Technical Service Bulletin: TSB140042

Released Date: 22-Apr-2014

FH239 Series Industrial Pro™ Stage 1 Fuel Filter and Water Separator (FWS)

Figure 1: Tall FH239 Series Industrial Pro™

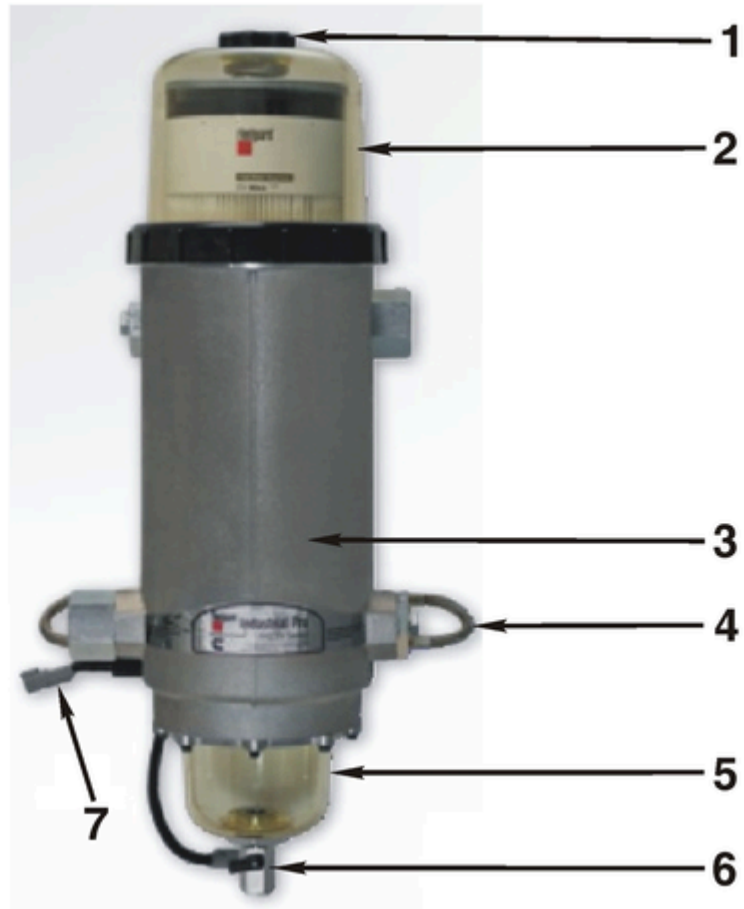
This document announces the improved FH239 Series Industrial Pro™ fuel filter and water separator (FWS), featuring NanoNet™ Technology for stage 1 filtration on all Cummins® high horsepower engines equipped with modular common rail fuel systems (MCRS). The new FH239 Series Industrial Pro™ FWS features the following improvements:

- Better filtration performance on all Cummins® MCRS engines (four times better than previous design)
- 500 hour fuel filter service intervals**
- Weight reduction
- Increased water holding capacity (five times more than previous design)
- Reduction in sealing joints
- Optional fuel heater

The improved FH239 Series Industrial Pro™ FWS comes in two sizes. The short version is to be used on the QSK 19 MCRS engines and the tall version is to be used on the QSK 38/50/60 MCRS engines. These were implemented in production in December of 2013.
